# Interface Control

LCGT f2f meeting  
Jul. 2012

*Tokyo Inst of Technology*  
**Kentaro Somiya**

# Transmission monitor system

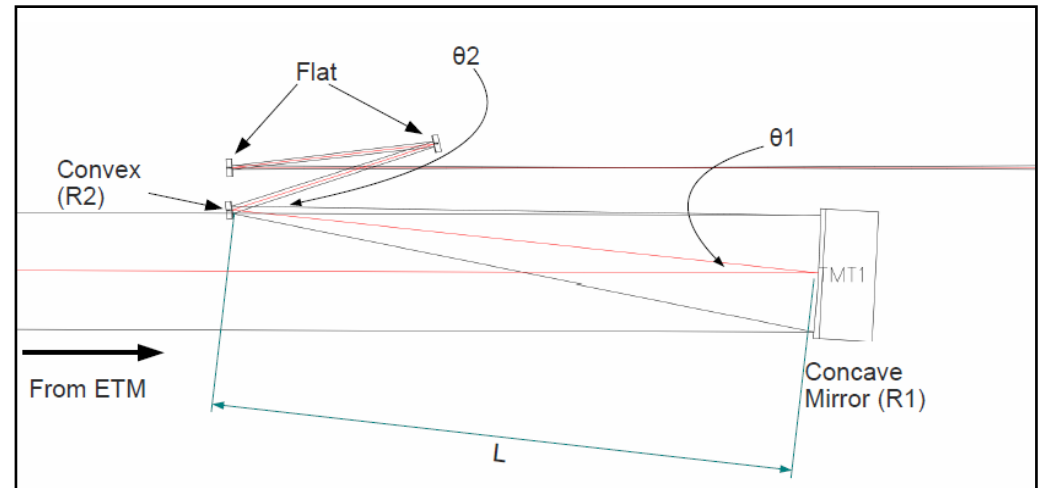
The values used to be... undetermined  
New values are... partially determined

- Layout update
- WFS sensitivity

\* no TMS for ITMs
